Unit / Module Description:	What is this all about?
Unit / Module Number:	FMC ADC 100M 14b 4cha card
Document Issue Number:	3.0
Issue Date:	3 rd December 2017
Original Author:	Steve Carpenter

CERN ADC Development report for FMC-ADC-100M

Performance issues previously measured on the FMC-ADC-100M are fully analysed,
and recommendations are made to correct these issues where practical.

Figure 2: FFT of RF field adjacent to channel 1

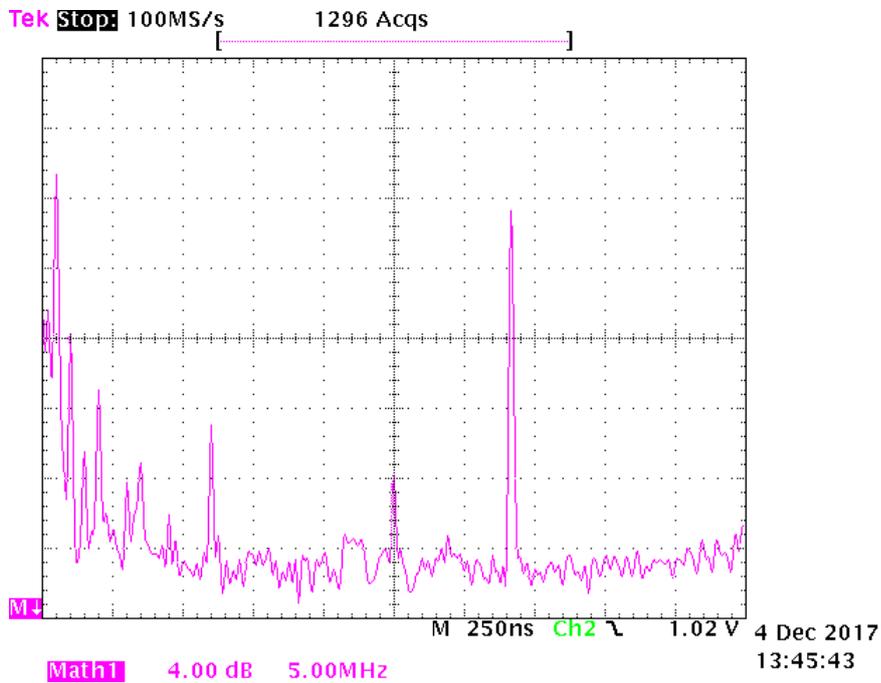
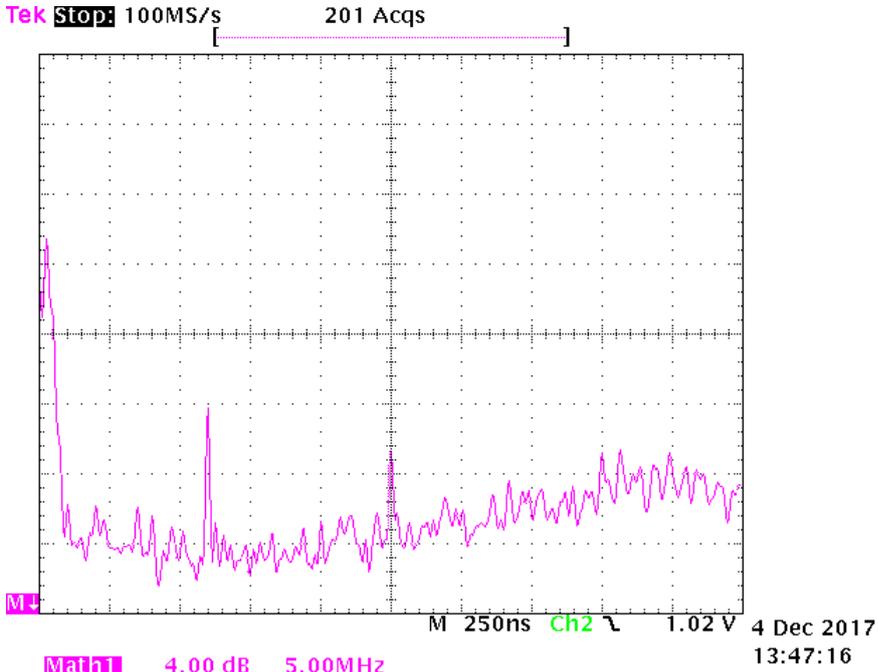
- 1. The band below 2MHz which peaks at about 24dB above the baseline.
- 2. The spot frequency of 33MHz which is about 20dB above the baseline for channel 1 only.

Both are stronger at the channel 1 side of the ADC, compared to the channel 4 side. This is expected because channel 1 is nearest the PC back plane.

Figure 4: Partial schematic of Channel1

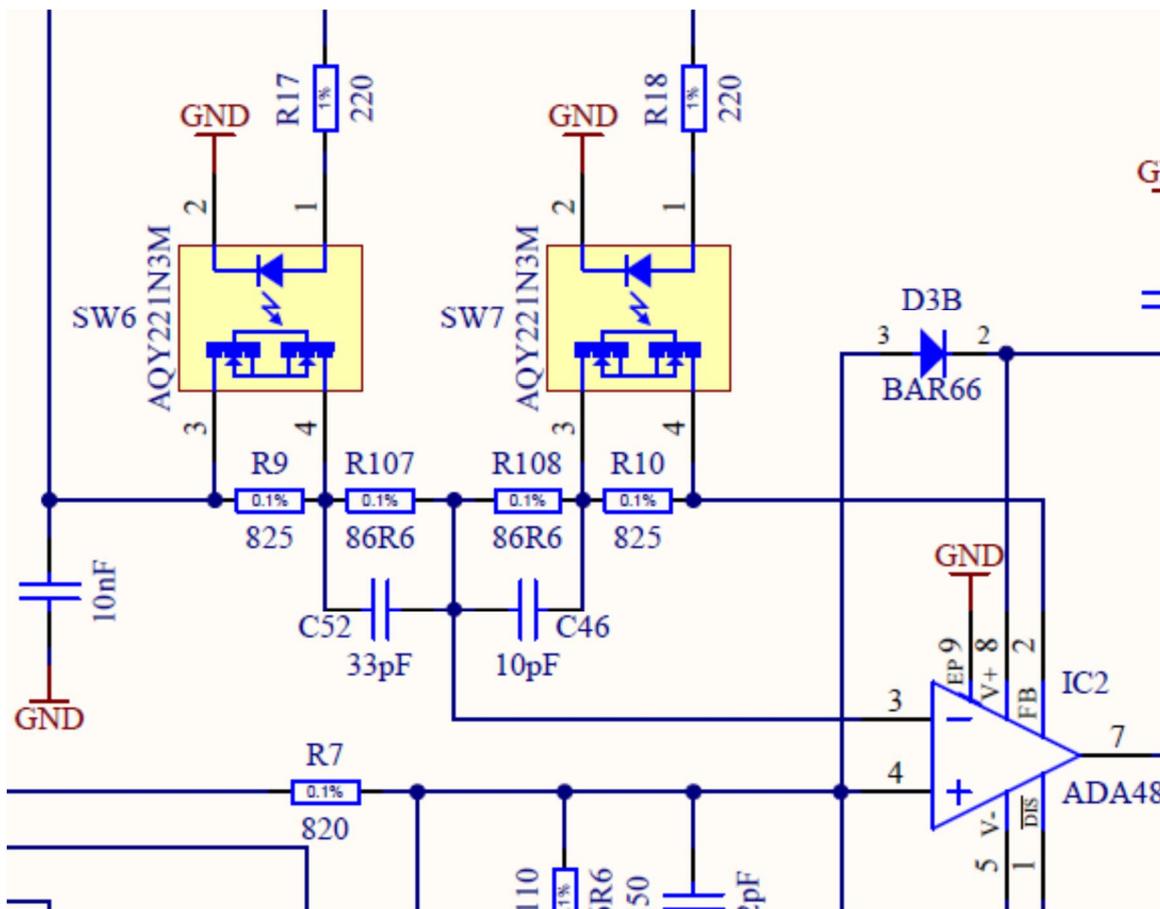
Only the amplifier input stage is affected by changes in gain. The amplifier is Analog Devices part ADA4899. This device has a negative feed back path consisting of 4 resistors, 2 with high frequency bypass, and 2 opto switches which allow the amount of feed back to be changed. The partial schematic below shows how this is arranged:

It is well known that the distortion in an amplifier is inversely proportional to the feed back, because greater feed back allows the amplifier to better correct any output error. It is less well understood that the effective feed back is proportional to its phase. So if the feed back is phase shifted at higher frequencies, then these frequencies will have higher distortion because the feed back is less effective. Increasing gain increases phase shift at high frequencies causing higher distortion.

This shows the second harmonic distortion at 8MHz can be 12dB worse at a gain of 5 compared to a gain 1, and is likely to be higher at higher gains.

The fundamental problem is setting a high gain of 11.6 in a single stage amplifier. The same gain could be obtained from a 2 stage amplifier with each stage set to a gain of just 3.4, which would have lower overall high frequency distortion. As the design already has 2 amplifier stages, the gain balance in the amplifier could be changed by increasing the output stage gain and reducing the input stage gain, so the net result is unchanged. This would reduce the distortion in the first stage and increase it in the second. The optimum gain balance would then have the same distortion in each stage. The problem with this approach is that the output stage distortion is then increased slightly for all 3 input ranges, making it less desirable.

An alternative solution is to add an additional amplifier stage. This could have a switched gain of 1 for the input ranges 1V and 10V, and a gain of 5.8 for the 100mV range. One of the optical relays that are used in the existing design to increase the first stage gain to 11.6 could be re-used to switch the gain on this additional stage, so the number of relays does not change. The problem with this approach is there is insufficient pcb space for the additional amplifier stage.

Figure 5: Ref 1 RMS dB Magnified Frequency Response of ADC Sn:139 Ch1 +/-0.5V

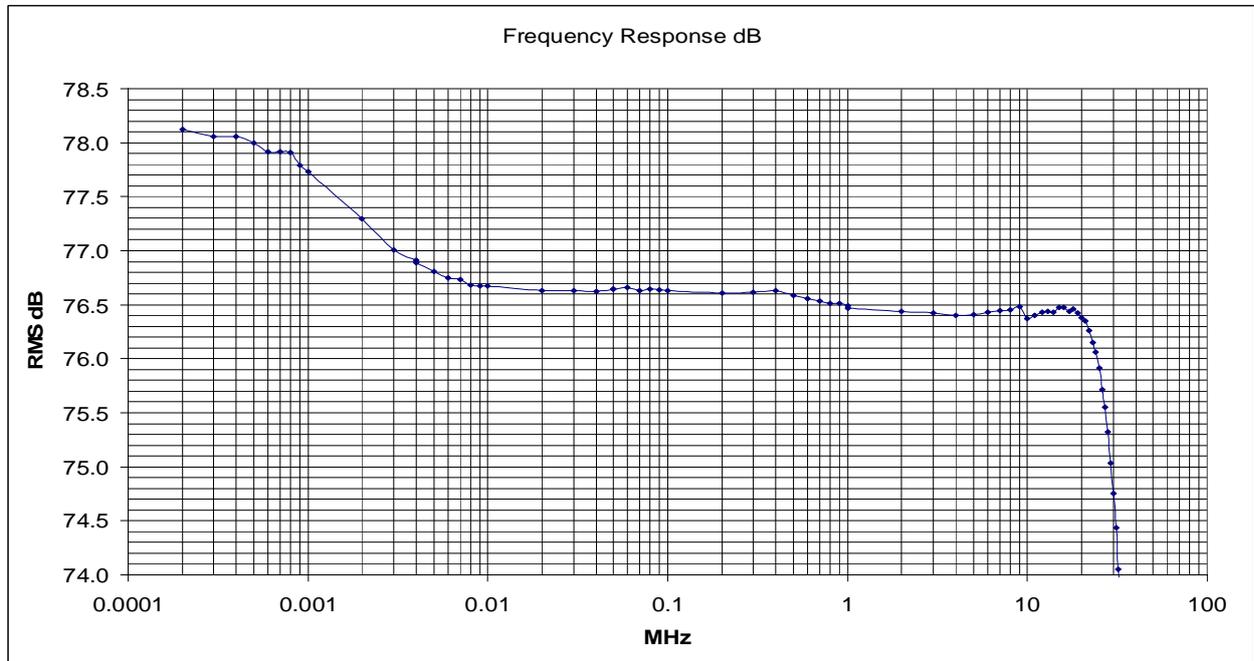
The frequency response shows a rise of around 1.5dB below 10kHz. The graph below is taken from ref 1 figure 17, and shows the frequency response of channel 1 on the +/-0.5V range:

Below 10kHz the response rises by around 1.4dB.

Careful examination and repetition of the method used in ref 1 revealed that the rise in response was caused by the Analog Devices HMC1030 dual 3.9GHz RMS power detector, even though it was fed from a DC-microwave signal splitter. The HMC1030 is AC coupled with a 50 Ohm termination on chip. This means at low frequencies it presents an impedance which rises above 50 Ohms, and the signal level from the splitter increases. The signal level on the other output of the splitter also increases slightly. However with the oscilloscope connected to the output of the signal generator, it does not measure this small increase in the signal fed to the ADC. The result is a small measured rise in the response at low frequencies which is NOT caused by the ADC circuit.

Figure 7: Frequency Response of existing inter stage filter

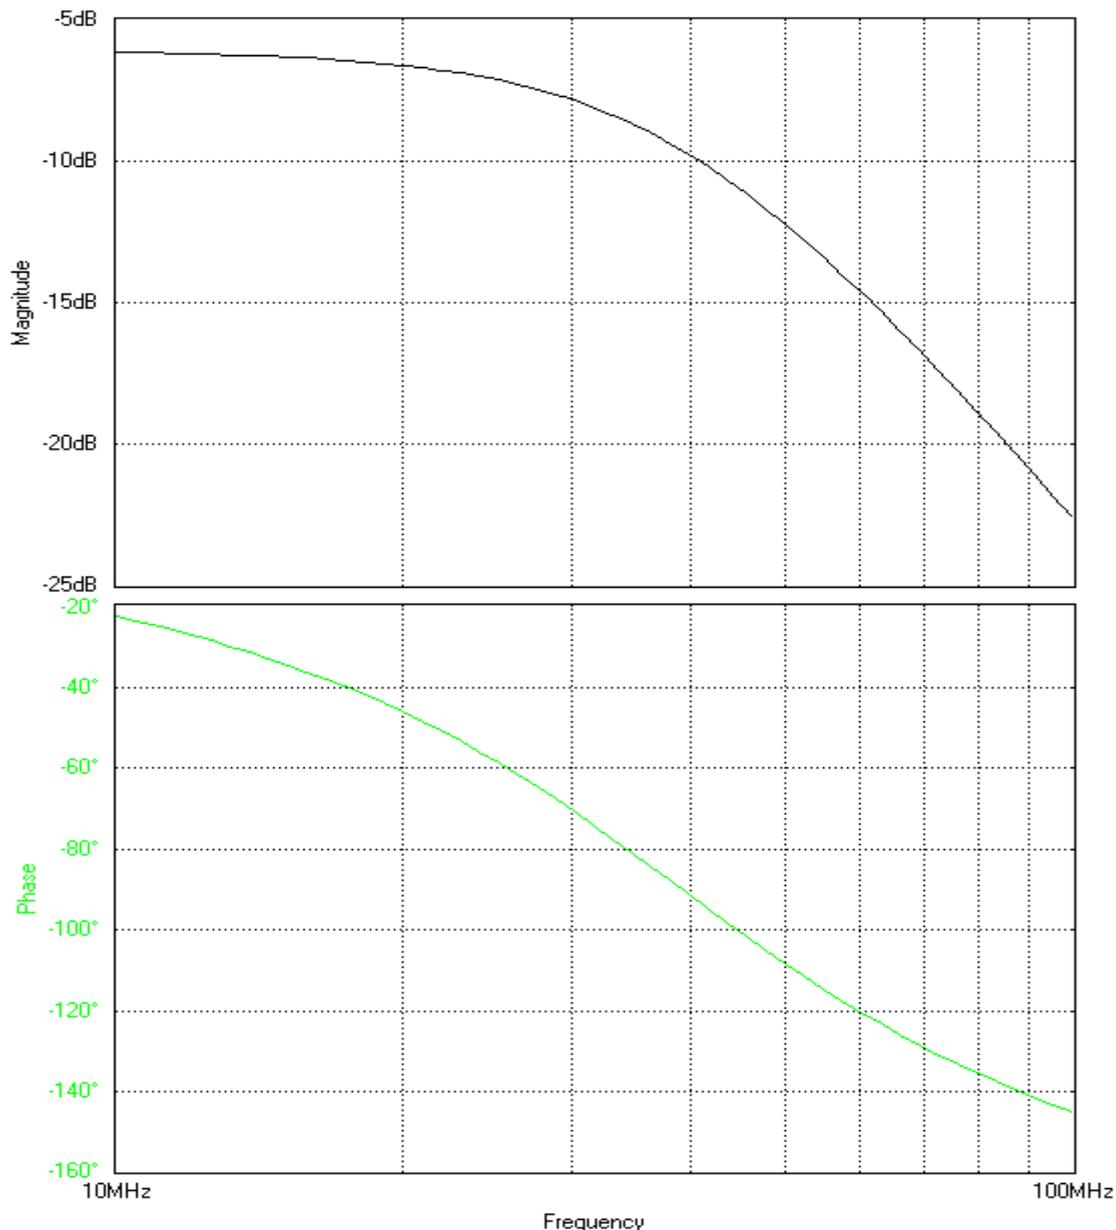
The measured frequency response is only -12dB at the Nyquist frequency of 50MHz, so frequencies above this will be aliased.

The first filter consists of 121 Ohm series resistor, 1uH series inductor, 33pF load, 121 Ohm load. Here are the results of modelling the first 1uH filter:

27.8MHz = -1.5dB
 36.5MHz = -3dB
 50.0MHz = -6.2dB
 100MHz = -16.5dB or 10dB/Octave
 Phase:
 30.0MHz = -71 degrees

Taking all this into account, it is recommended that the inter stage order 2 filter is replaced with an order 5 filter. The graphs below show the results of modelling a practical order 5 filter:

Figure 8: Frequency Response of existing output filter

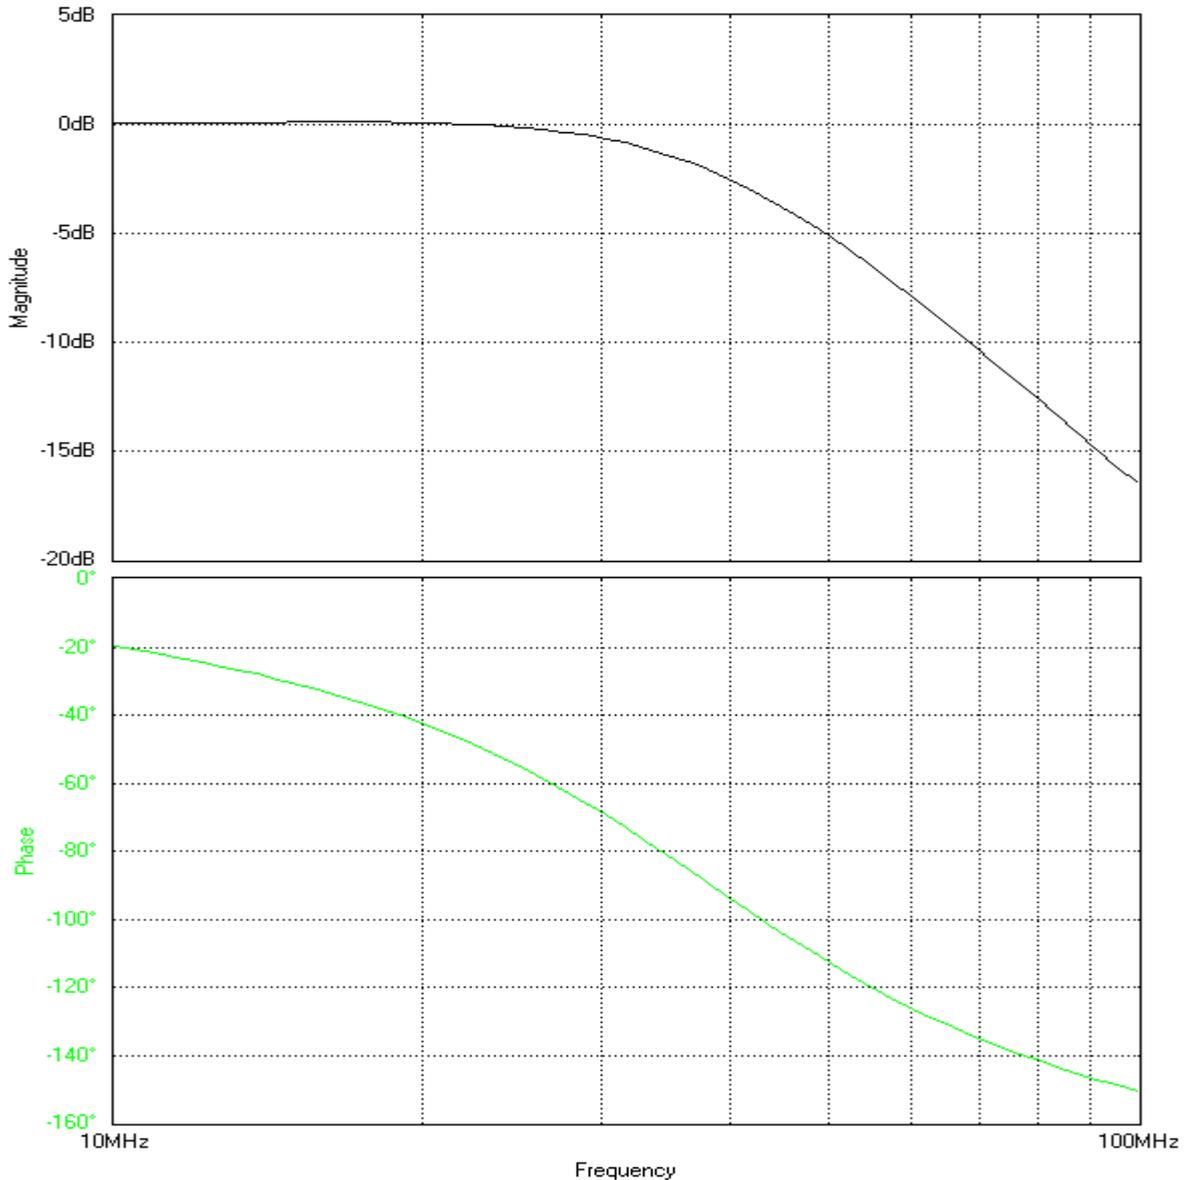
The second filter consists of a differential input feeding series 121 Ohm resistor, series 390nH inductor, single 22pF output capacitor. Here are the results of modelling the second 390nH filter:

35.3MHz = -1.5dB
 42.2MHz = -3dB
 50.0MHz = -5.1dB

The 22pF output capacitor is in parallel with the ADC input capacitance, so the roll off frequencies will be slightly lower.
